15A Plant Nuclear Safety Operational Analysis (NSOA)

The information in this appendix of the reference ABWR DCD, including all subsections, tables, and figures, is incorporated by reference with the following departures.

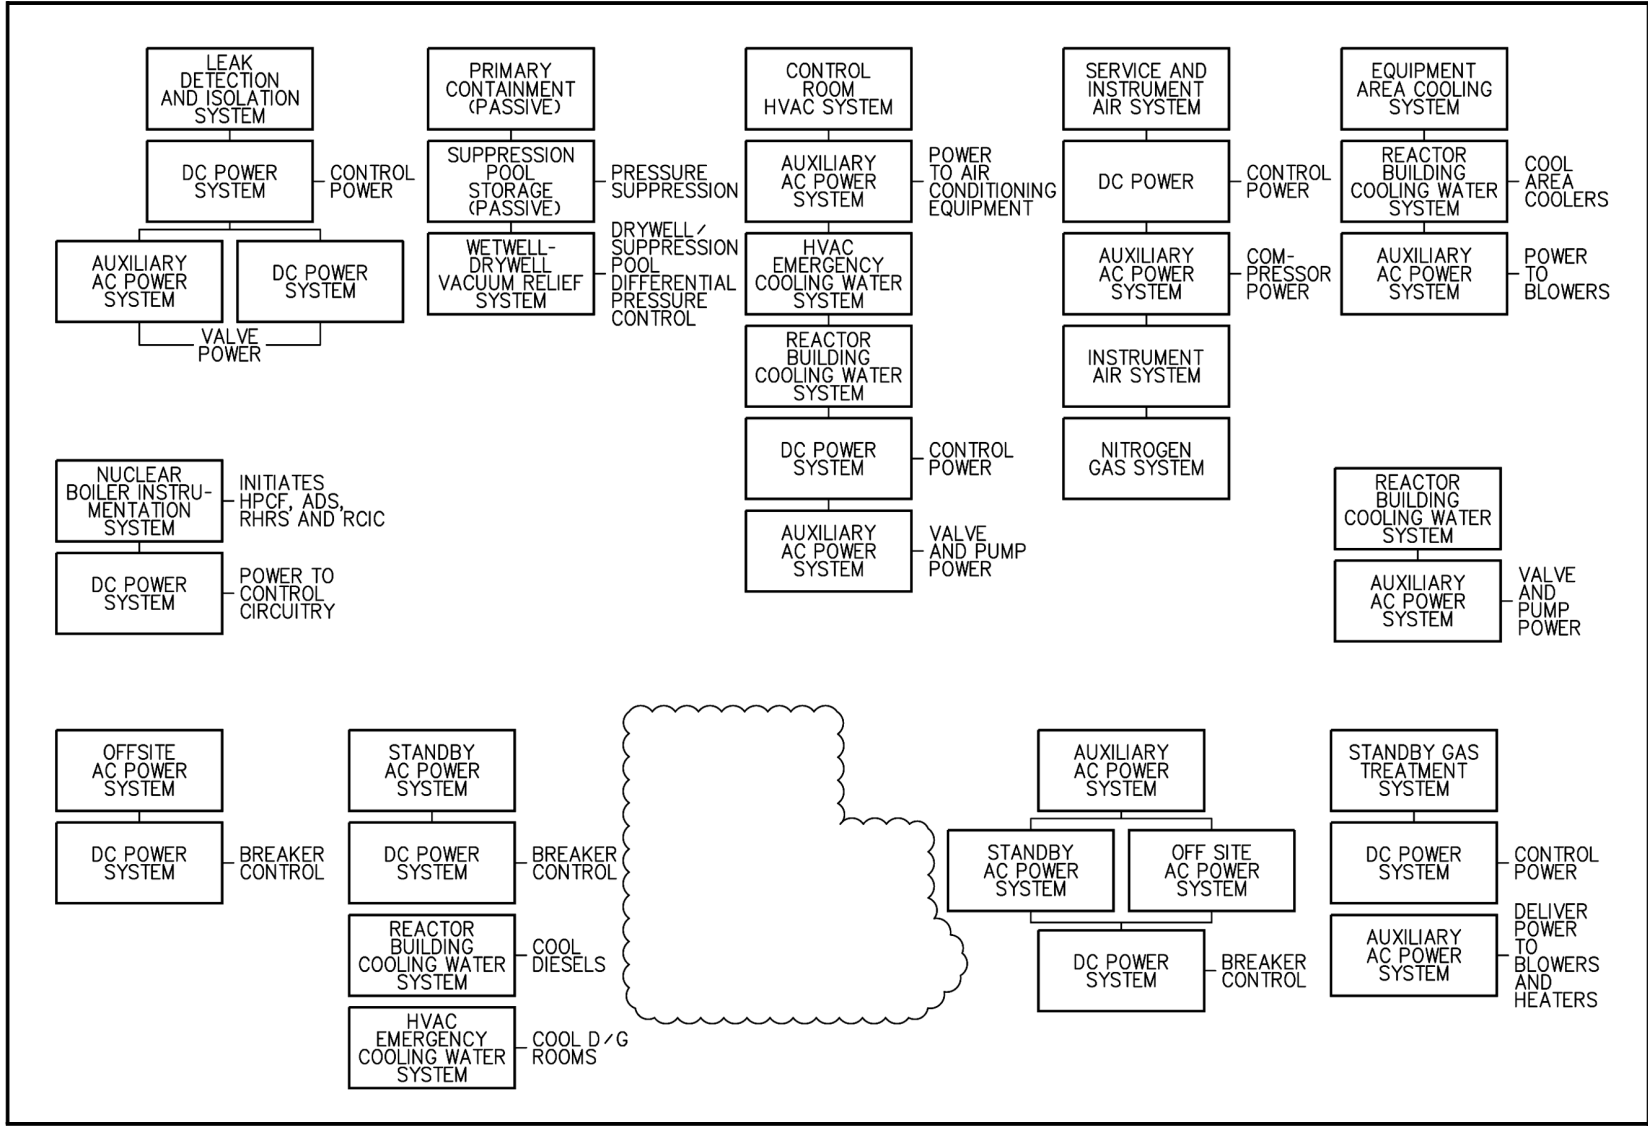
STD DEP T1 2.14-1 (Figure 15A-7)
